Embankment FailureBrant County Road No 8 (White Swan Road)  
1 mile of Hwy. # 53.Effective Stress Stability Analyses

Re: Embankment Instability  
White Swan Road, Brant County  
Road No. 8

Re: Embankment Instability - Brant County  
Road No. 8 - White Swan Road

DEPARTMENT OF HIGHWAYS MATERIALS and TESTING OFFICE ONTARIO	COUNTY ROAD 8 - SLOPE FAILURE REMEDIAL MEASURES	
	COUNTY OF BRANT	TOWNSHIP OF BRANTFORD
DATE DECEMBER 14, 1970	CONT. NO. D.R. 937-1	DRAWING NO. 70-11119 A

FIGURE NO 1.

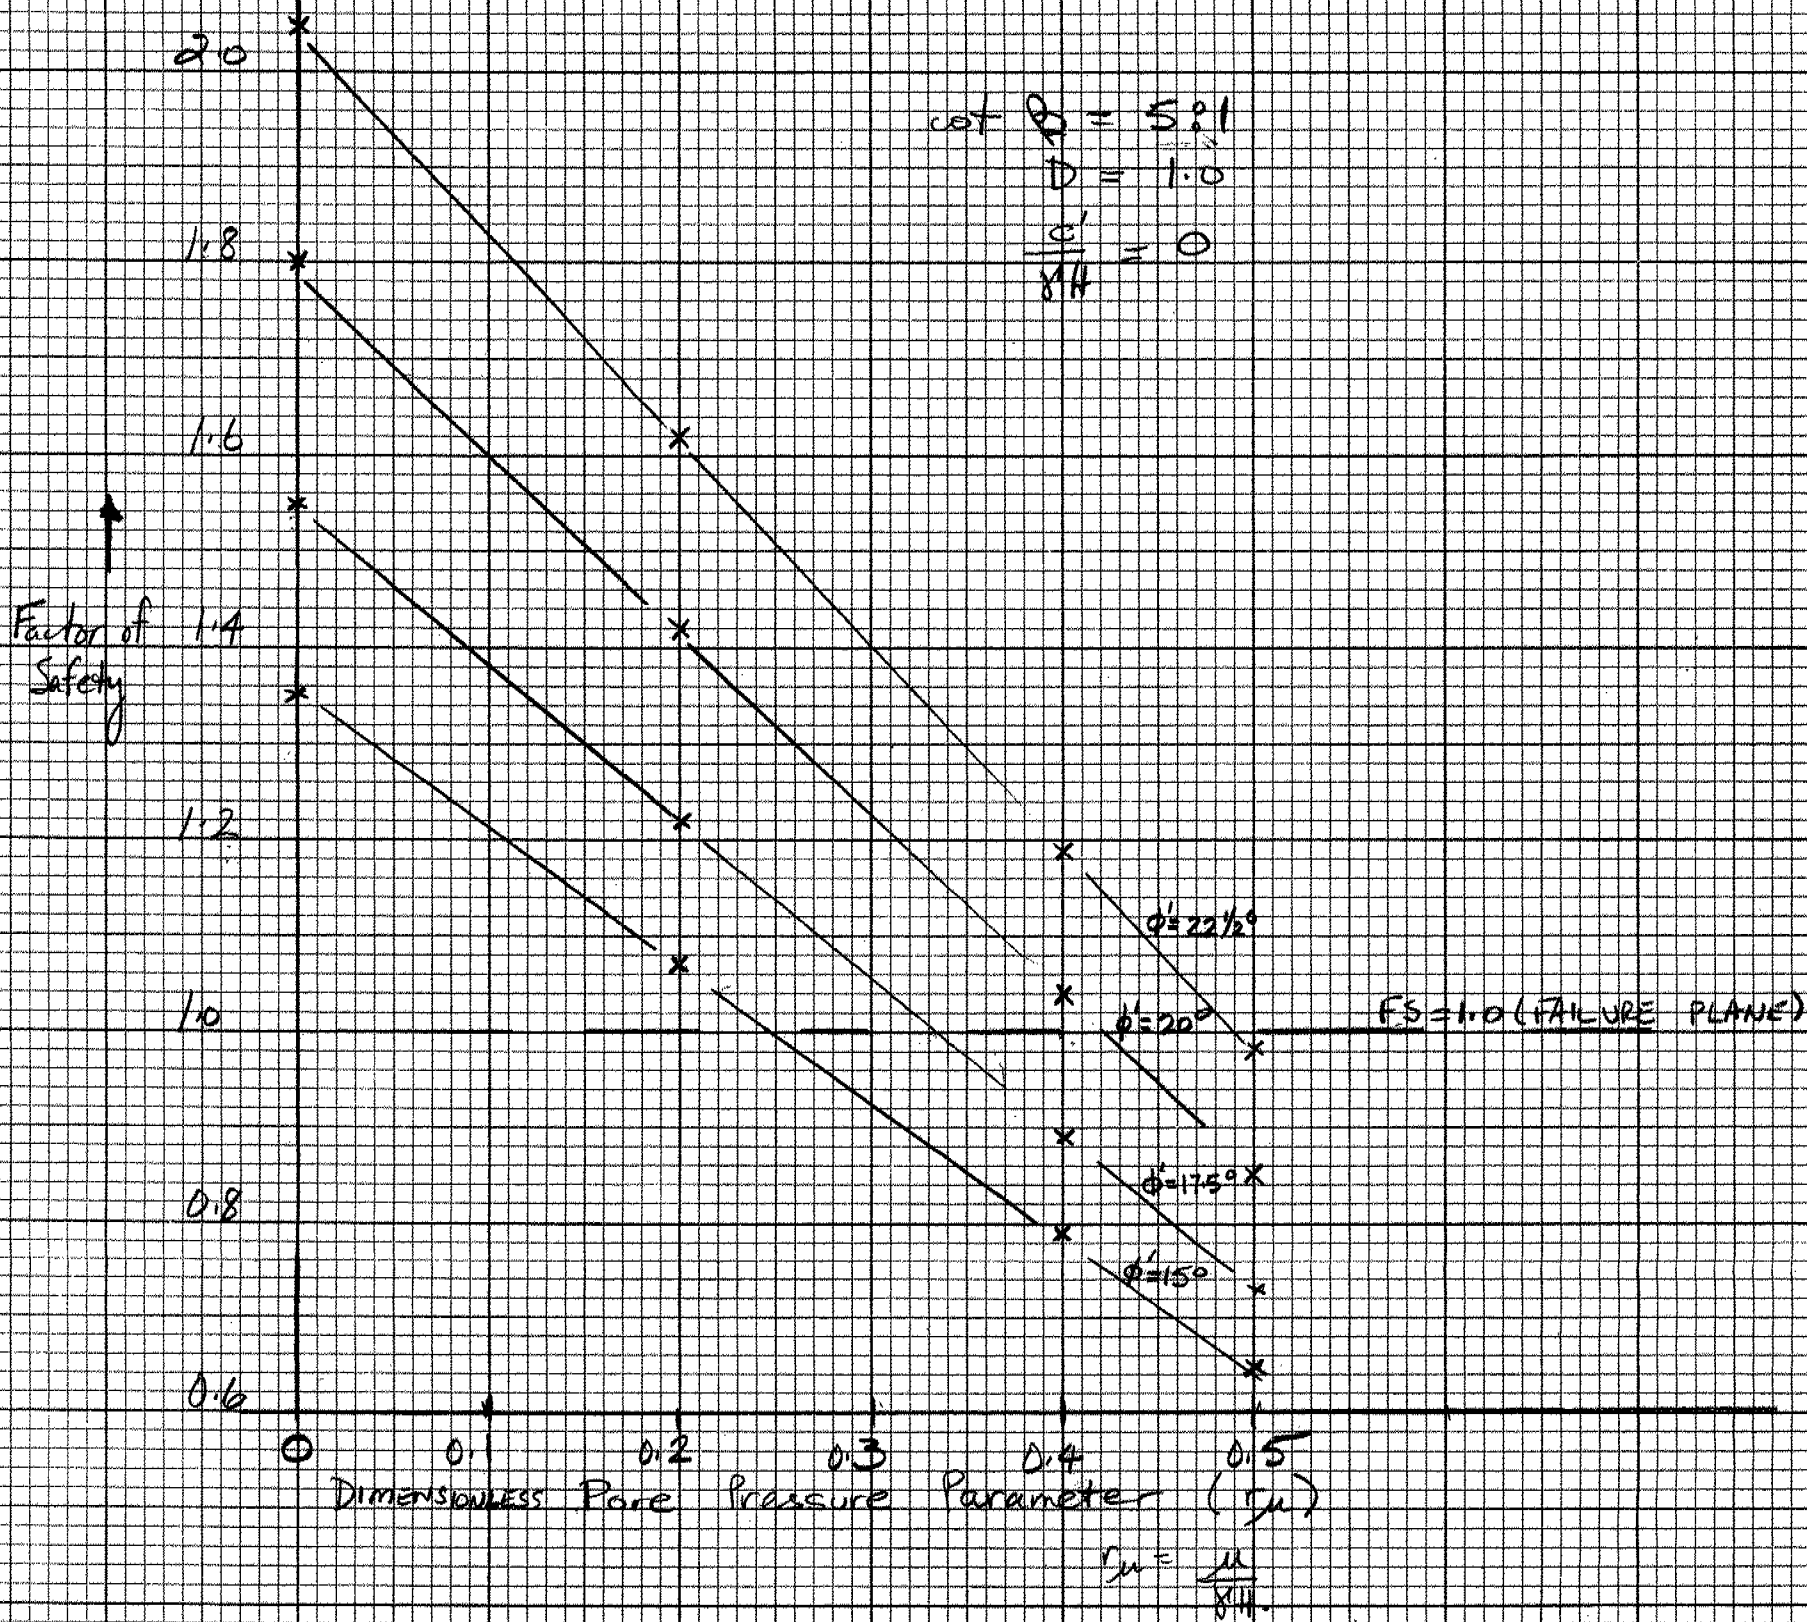
Referring to Figure #1

Most Likely combination of Failure:

- $\phi'$  somewhere between 17° and 19°.
- $r_u$  " " 0.35 and 0.40.
